# Final Report

## Evaluation of Natural Resources Conservation Services Flood and Sediment Control Structure Conditions to Better Estimate Erosion Rates

**Texas Water Development Board**  
TWDB Contract No. 1148321309

**URS Corporation**  
**Texas Firm No. F3162**  
9400 Amberglen Blvd.  
Austin, TX 78729

**Figure 1-1. Basic Configuration of NRCS-Designed Flood-Retarding Structures**

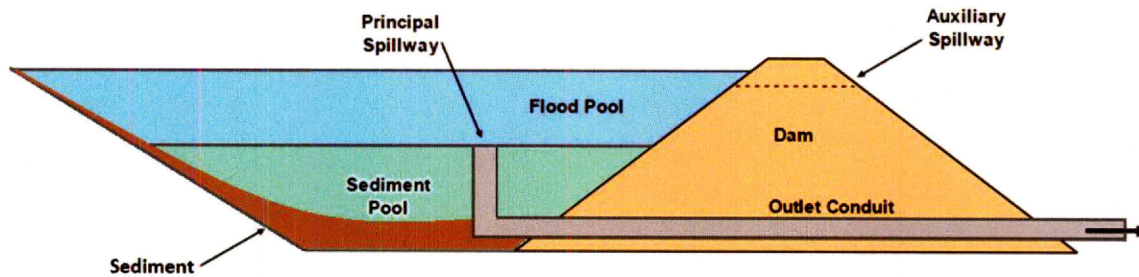
1. Page 1-1. Figure 1-1 is an over simplification of how NRCS-Designed Flood-retarding Structures generally work. The area label sediment pool implies all or most sediment deposition will occur in this area. Much of the sediment deposition occurs outside of the area labeled sediment pool, as the water surface raises and slopes are reduced heavier materials such sand and large silt size materials deposit in the upstream channels and on the banks of the pond. Please consider a better illustration.
2. Pages 2-26, 1st paragraph, 1st sentence, please provide possible reasons why the densities are so different if you can.
3. Page 2-51, please include a definition for significance F for this is a less popular statistic and some readers may not be familiar with it.
4. Page 3-1, explain why your methodology is for an “economic” survey.

URS Responses to TWDB Comments			
Comment No.	From	Comment	URS Response
<b>Minor Comments</b>			
1	TWDB	Page 1-1. Figure 1-1 is an over simplification of how NRCS-Designed Flood retarding Structures generally work. The area label sediment pool implies all or most sediment deposition will occur in this area. Much of the sediment deposition occurs outside of the area labeled sediment pool, as the water surface raises and slopes are reduced heavier materials such sand and large silt size materials deposit in the upstream channels and on the banks of the pond. Please consider a better illustration.	Figure has been replaced
2	TWDB	Pages 2-26, 1st paragraph, 1st sentence, please provide possible reasons why the densities are so different if you can.	Possible explanations provided
3	TWDB	Page 2-51, please include a definition for significance F for this is a less popular statistic and some readers may not be familiar with it.	Definition provided
